Memorandum

Subject Proposed Alluvial Gold Mine, Luggate Cromwell Road, Sandy Point. Response to CODC RFI questions

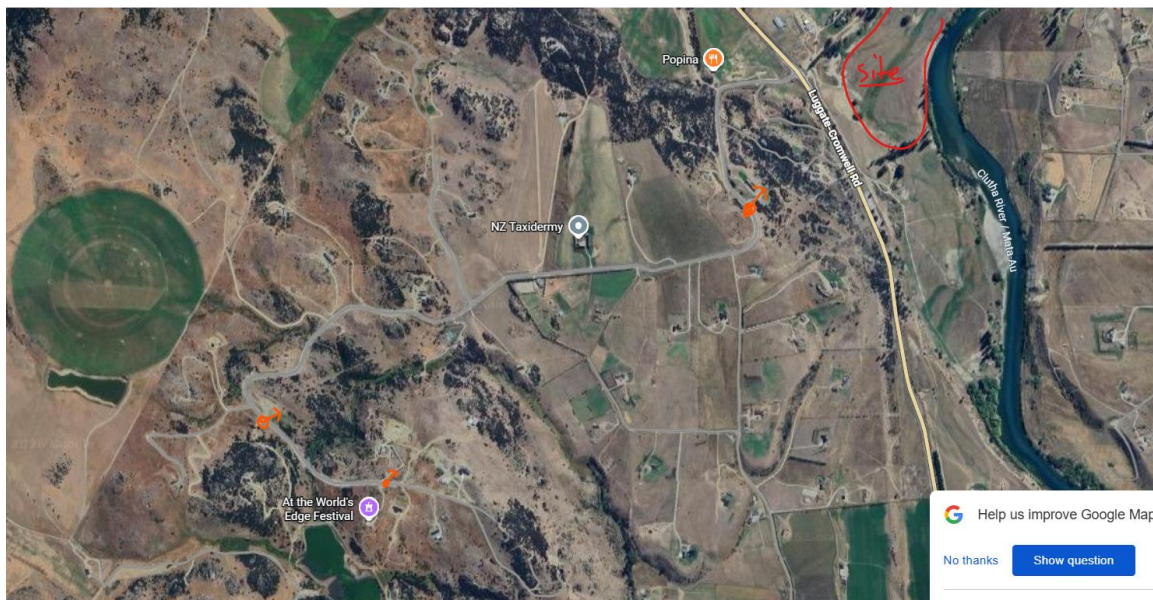
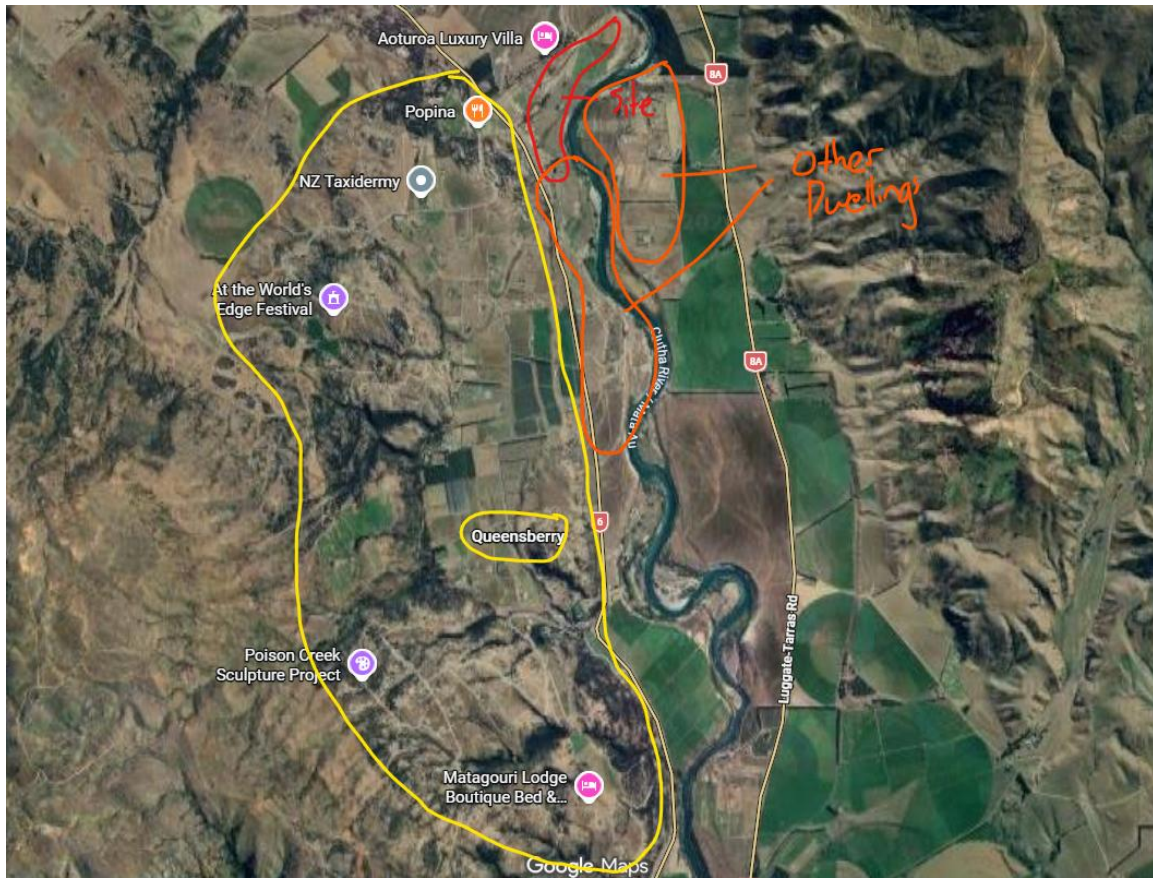
2. *There is no discussion in regard to the effects on visual amenity of surrounding north-west orientated dwellings located within Queensbury and Māori Point. Please provide an assessment of the effects on visual amenity of these private views.*

I understand that the dwellings in question are within the areas circled in the maps below, forwarded by CODC.

As noted in the LEA report the visual effects of the proposed activity from the many private dwellings in the area surrounding are assessed on the basis of representative public

viewpoints. Visual effects from two viewpoints on Pukerangi Drive are assessed and as noted, these are generally representative of effects from private properties on the slopes overlooking the site to the west (i.e. the area shown in the bottom image above).

Effects from the area marked (top image) to the east of the river (true left) are addressed in the LEA on page 16. There are no publicly accessible viewpoints in this area but as noted, assessment has been made on the basis of views back toward these dwellings from the site.

The more distant areas to the south of the site highlighted in the top image have not been specifically assessed but effects would either be screened by landform, minimised by distance and / or similar in character to those assessed from Pukerangi Drive (i.e. relatively distant viewpoints at a higher level overlooking the river flats).
